CITY OF DALLAS LANDMARK COMMISSION

Monday, February 3, 2020

AGENDA

Request #1 – Proposed Blade Sign
CA190-169(LC)

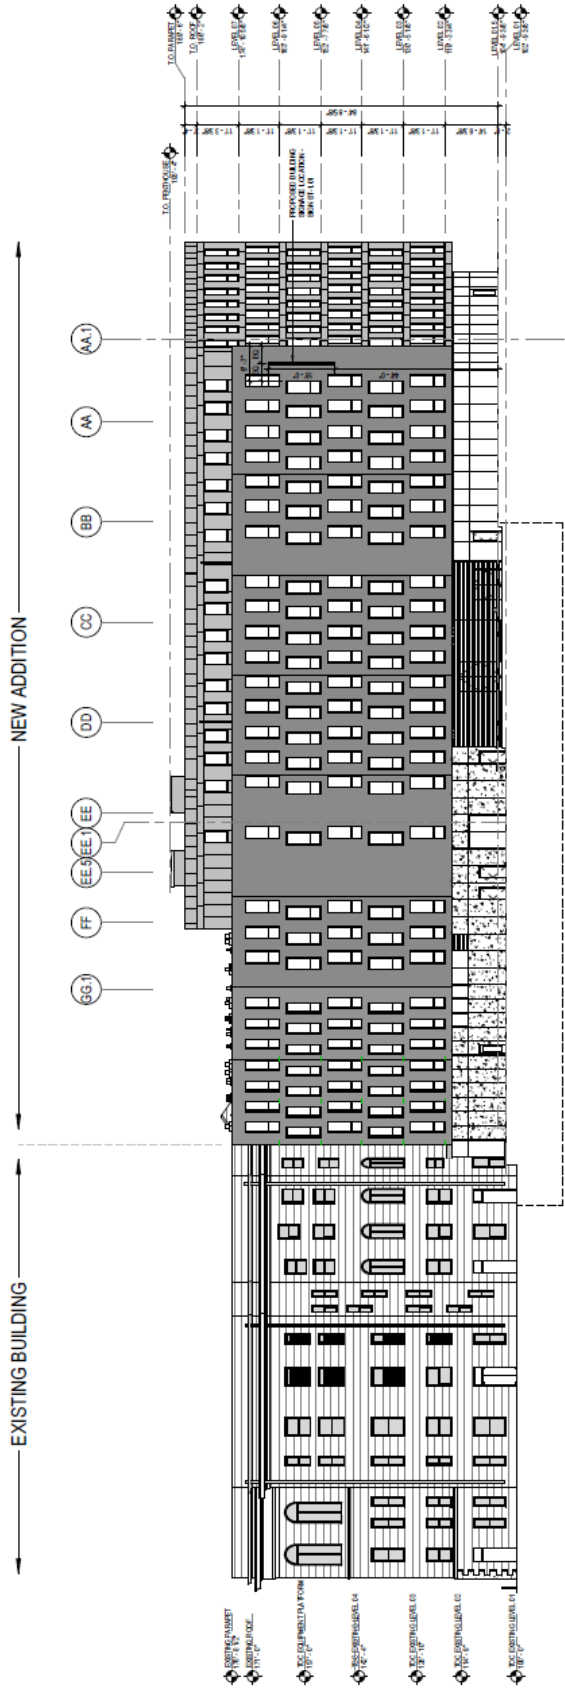
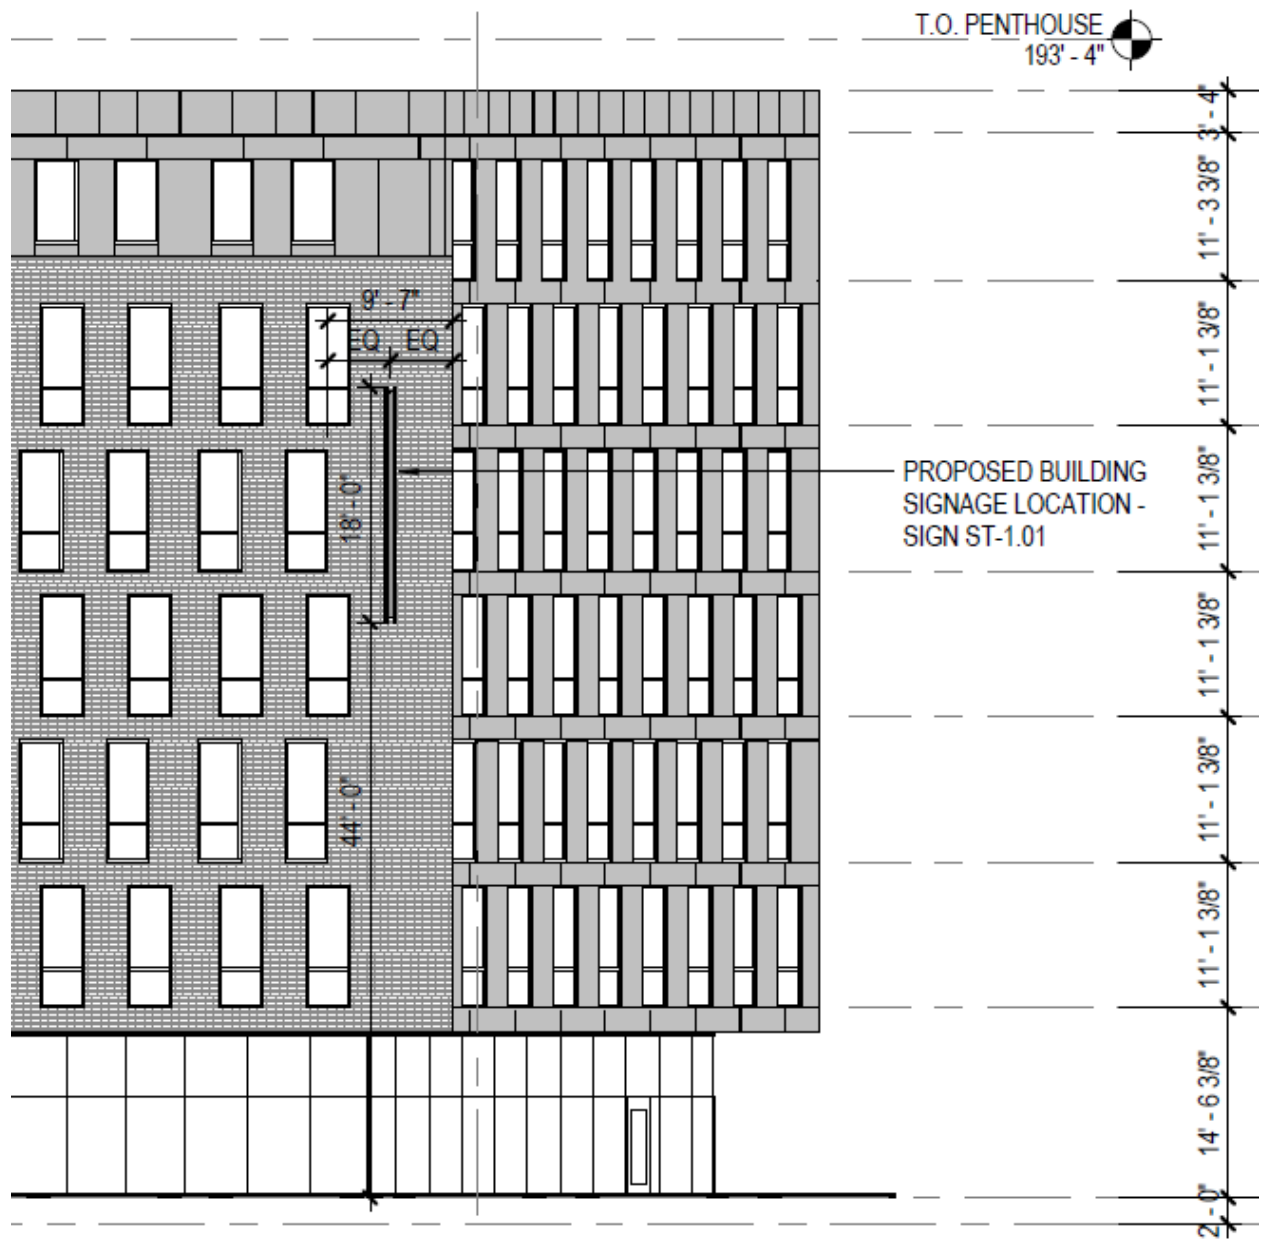
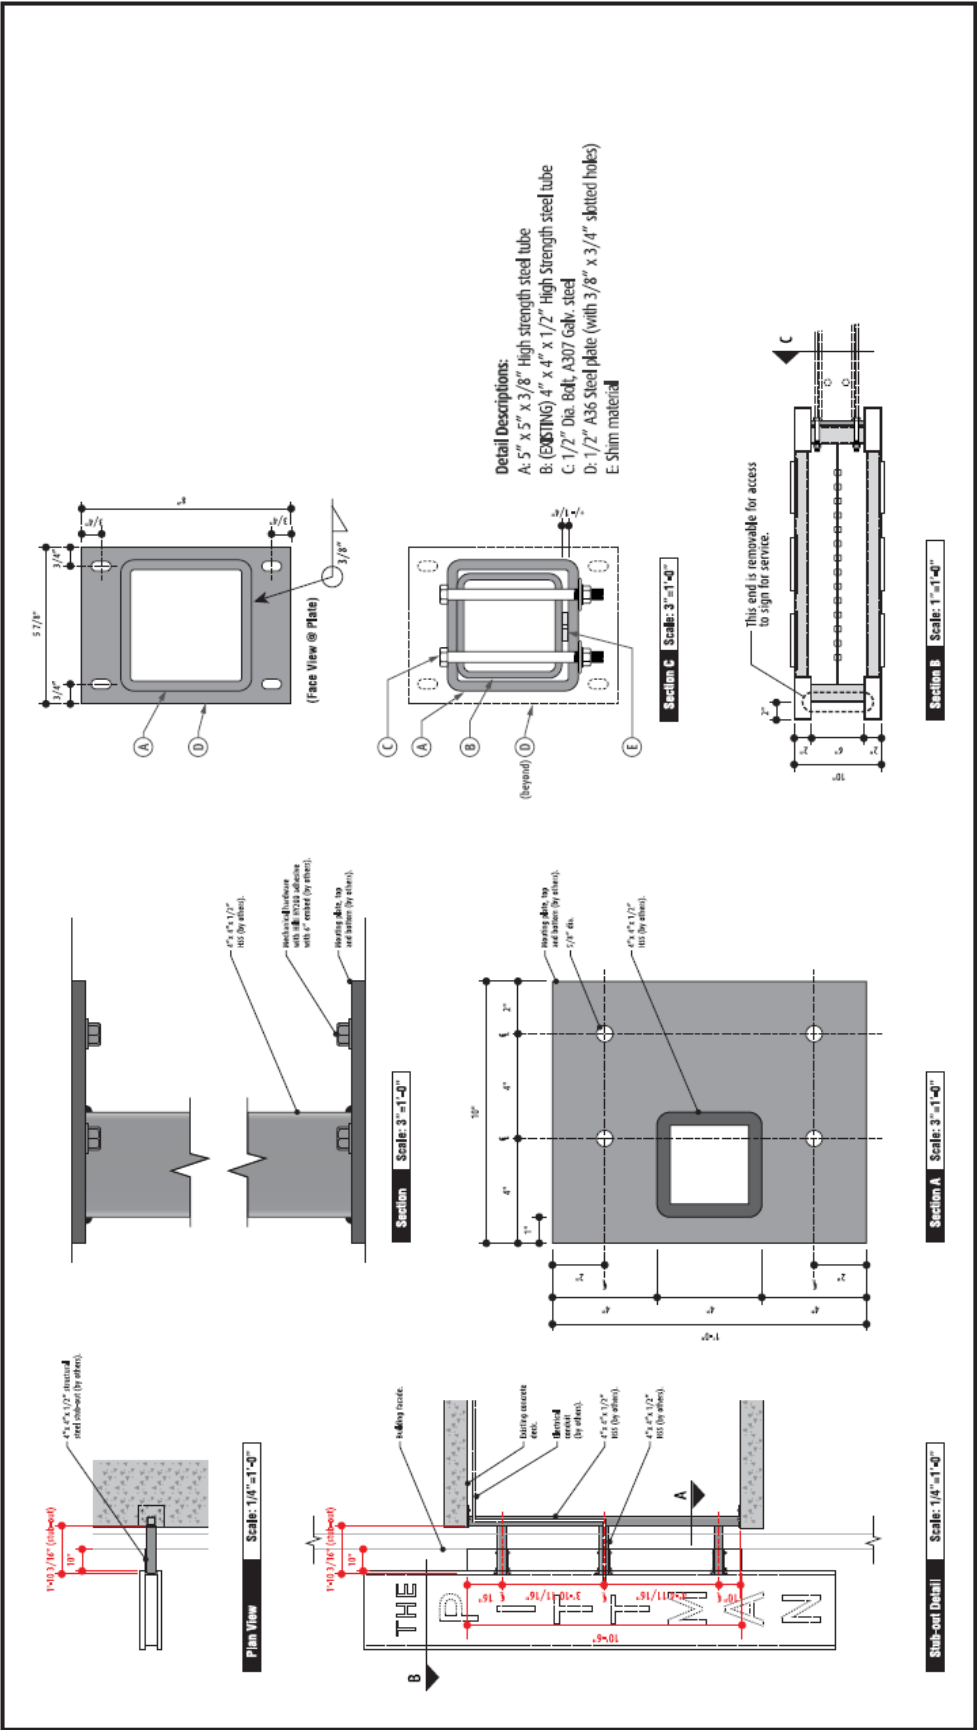
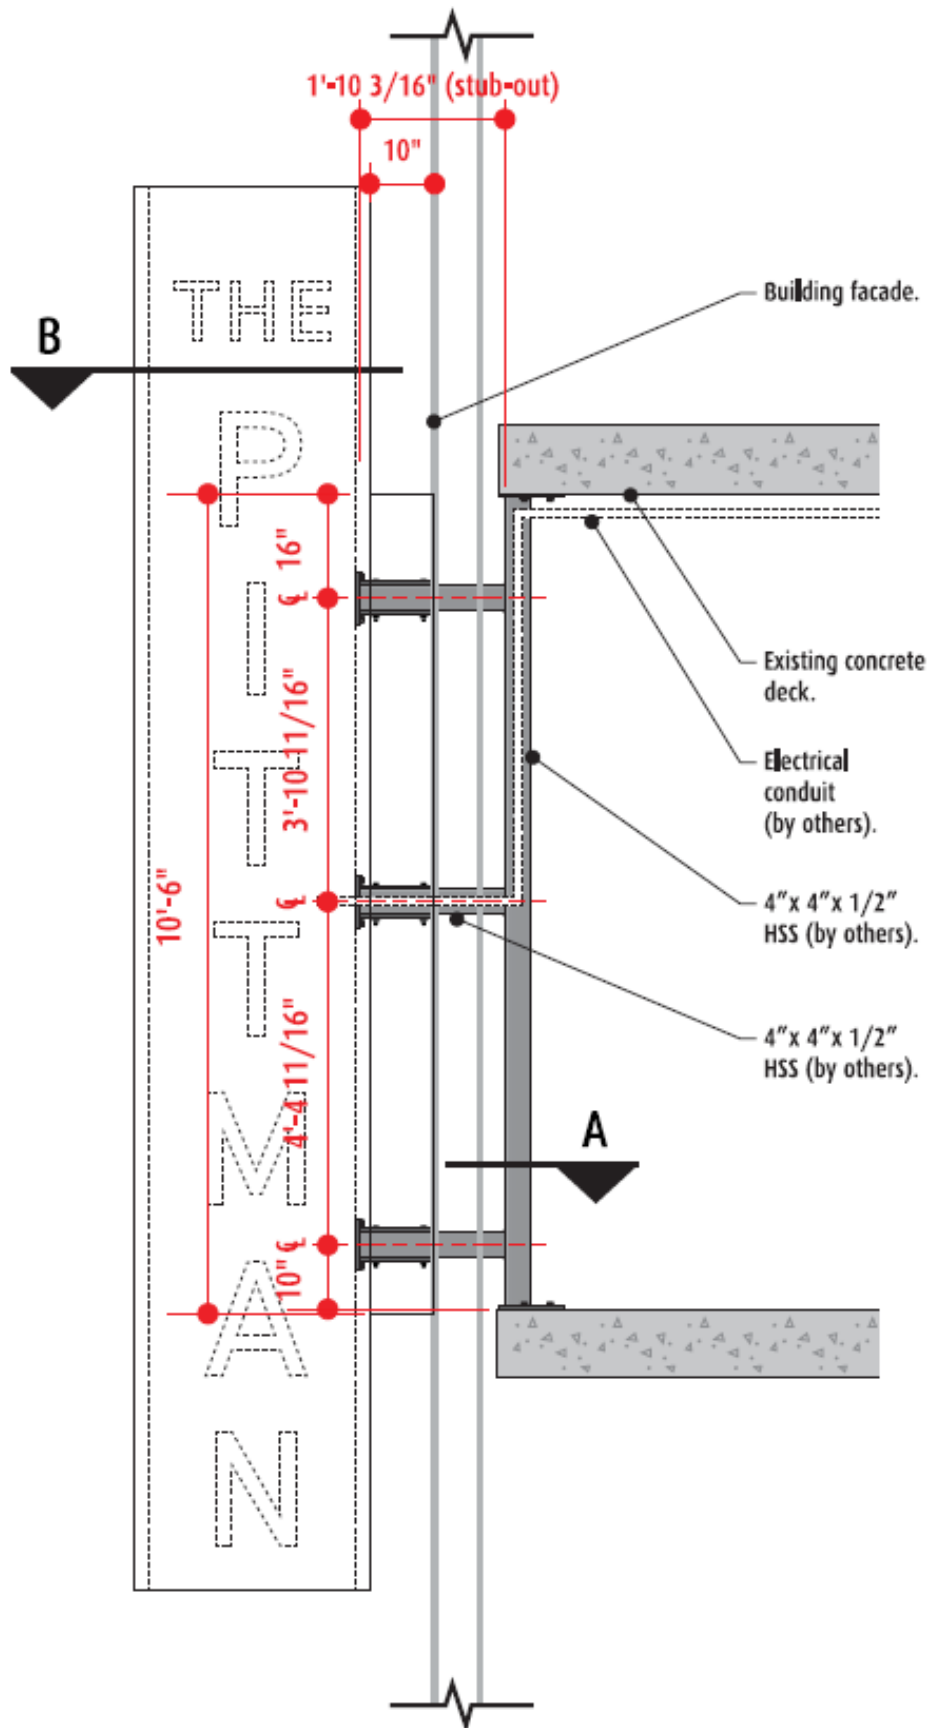
1. Install a blade sign on the east elevation - No quorum, comments only - Supportive.
2. Install canopy sign on the west elevation - No quorum, comments only - Supportive.
3. Install flat attached sign with light fixture above on south elevation - No quorum, comments only - Supportive; provide light fixture specifications for flat attached sign on south elevation; provide color elevation for Elm Street entry.
4. Install address numbers on south elevation - No quorum, comments only - Supportive; provide color elevation for Elm Street entry.

1. Install a blade sign on the east elevation – Approve – Approve drawings dated 2/3/2020 with the finding the proposed work is consistent with preservation criteria Sections 9.1 and 9.3 for signs, and meets the standards in City Code Section 51A-4.501(g)(6)(c)(i).

Request #3 – Proposed Flat Attached Sign

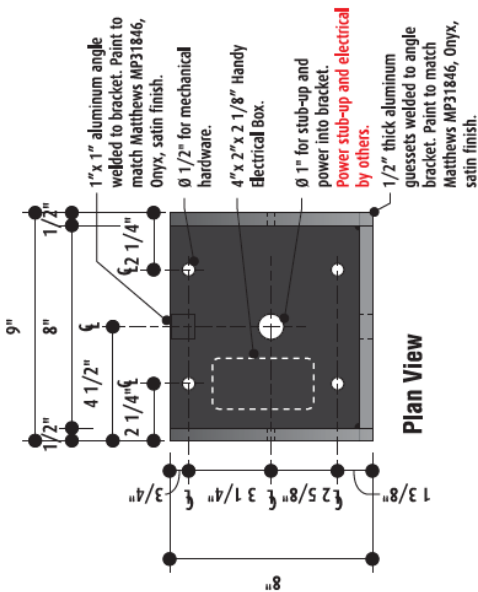
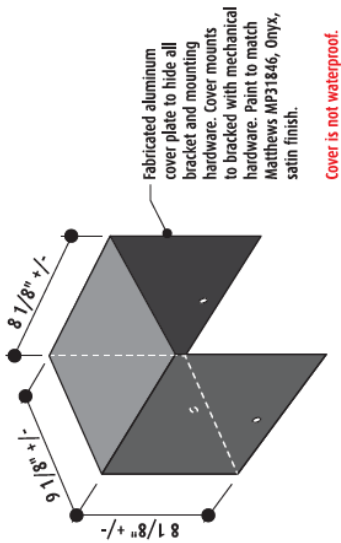
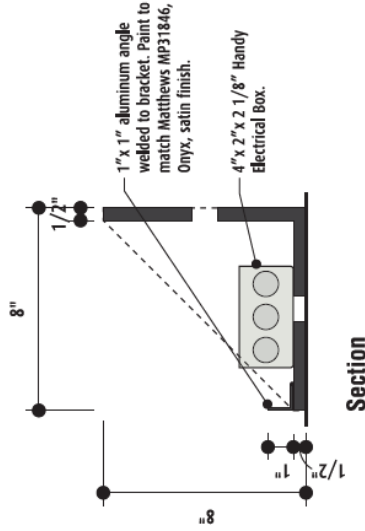
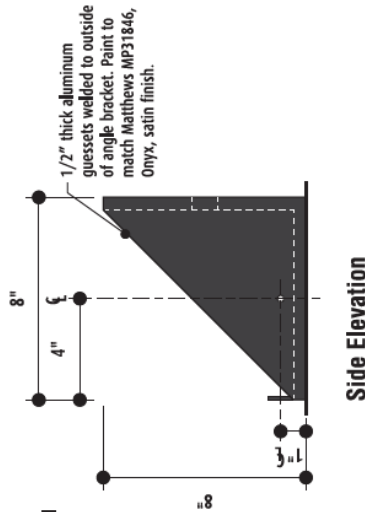
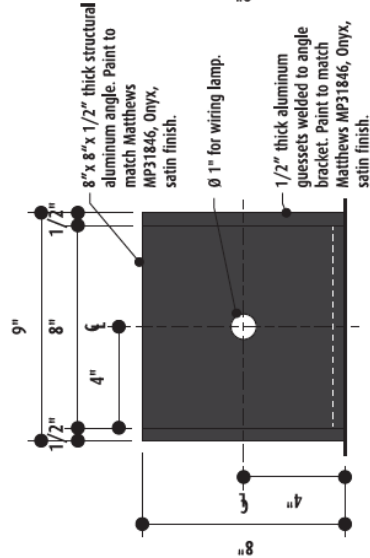
SUPPORT ; PROVIDE LIGHT FIXTURE SPEC ^{FOR} ST-15.01 SIGNAGE.
PROVIDE COLOR ELEVATION FOR ELM STREET ENTRY

3. Install flat attached sign with light fixture above on south elevation – Approve – Approve drawings dated 2/3/2020 with the finding the proposed work is consistent with preservation criteria Section 3.4 for lighting, Sections 9.1 and 9.3 for signs, and meets the standards in City Code Section 51A-4.501(g)(6)(c)(i).

NORTH ELEVATION

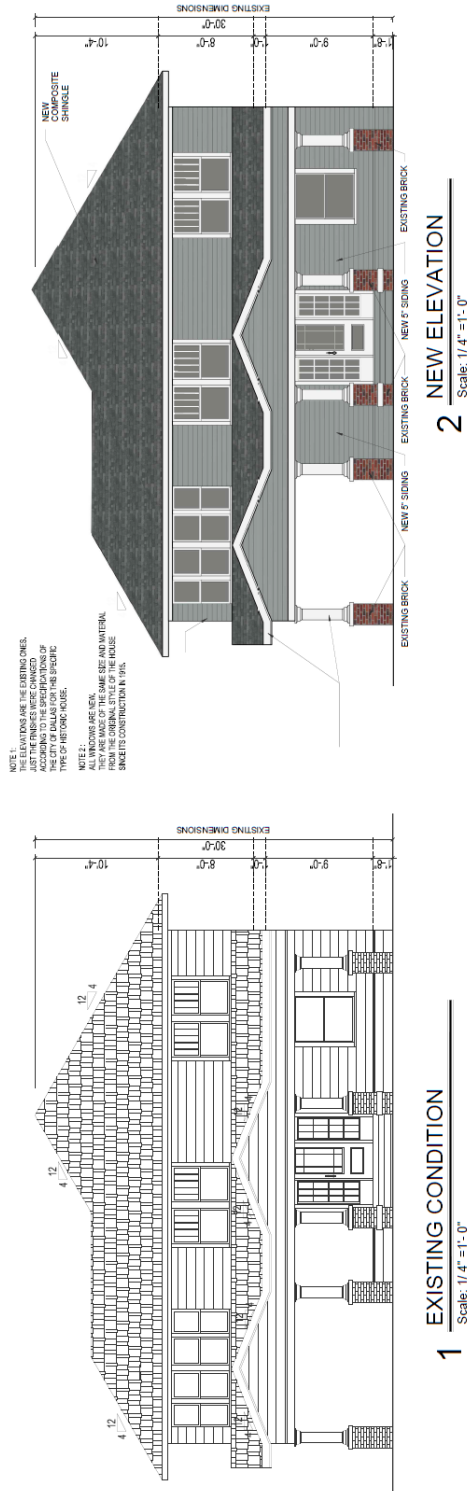
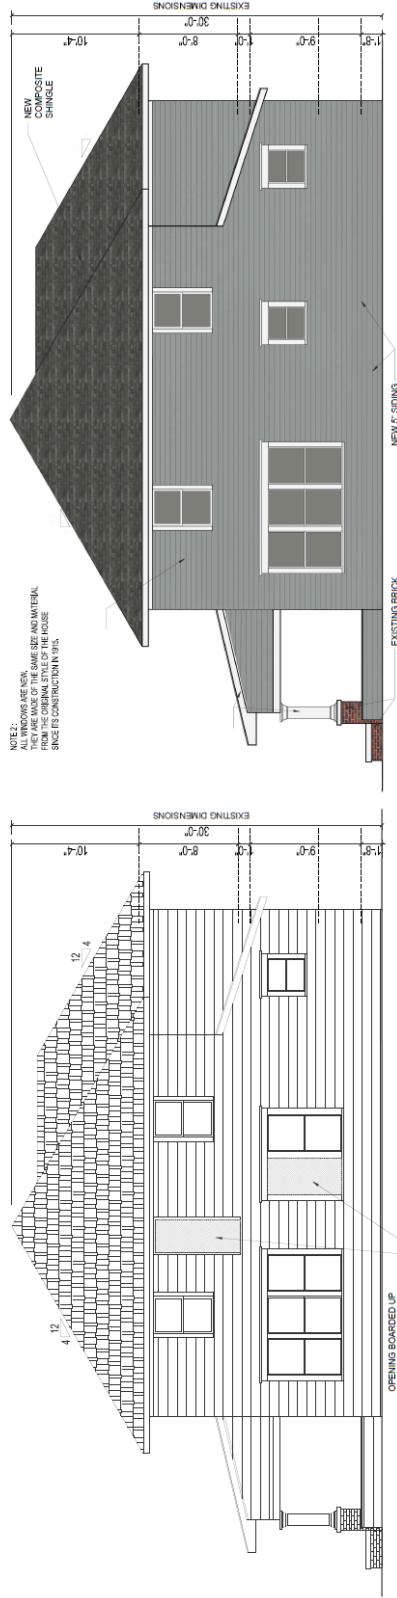
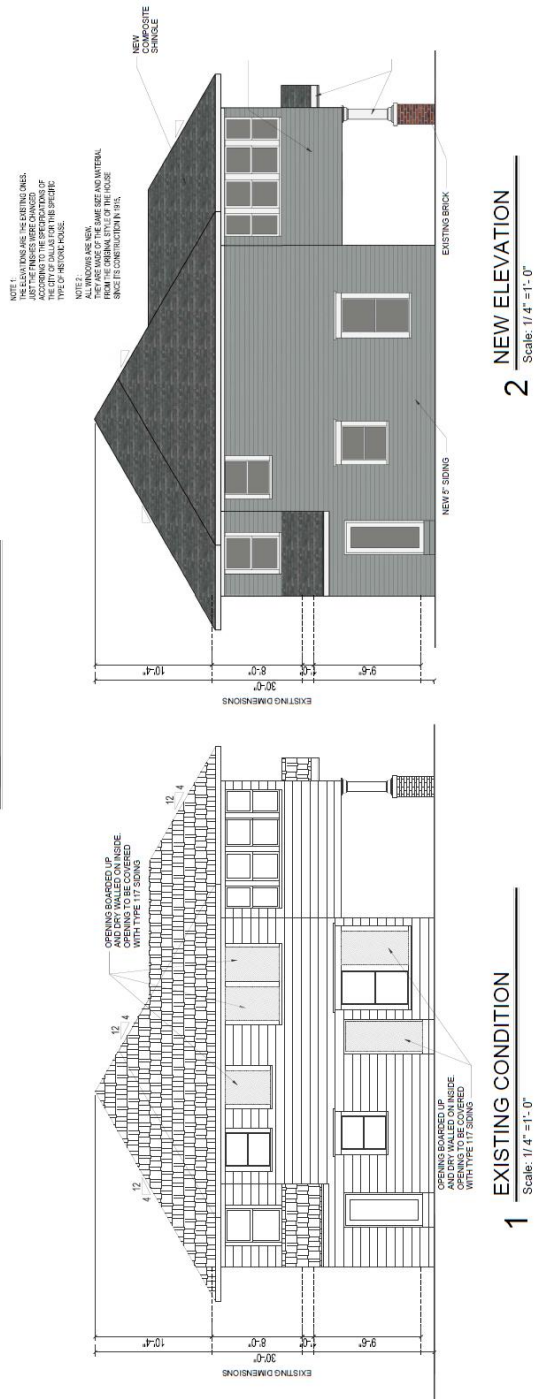
PROVIDE DETAIL JAM/HEAD, DIMENSIONED TYPICAL CUTSHEET

- 1) Replace fourteen windows on main structure with new wood windows - Approve - Approve specifications dated 2/3/2020 with the finding the proposed work is consistent with the criteria for windows and doors in the preservation criteria Section 51P-87.111(a)(17)(F)(iii) and meets the standards in City Code Section 51A-4.501(g)(6)(C)(i).

- 2) Remove openings #6, 9, #12, #25 and 29-33. Infill with new wood #117 siding - Approve - Approve drawings dated 2/3/2020 with the finding the proposed work is consistent with the criteria for windows and doors in the preservation criteria Section 51P-87.111(a)(17)(F)(iii) and meets the standards in City Code Section 51A-4.501(g)(6)(C)(i).

- 3) Replace and resize window openings #5 and #10 with new wood windows - Approve - Approve specifications and drawings dated 2/3/2020 with the finding the proposed work is consistent with the criteria for windows and doors in the preservation criteria Section 51P-87.111(a)(17)(F)(iii) and meets the standards in City Code Section 51A-4.501(g)(6)(C)(i).
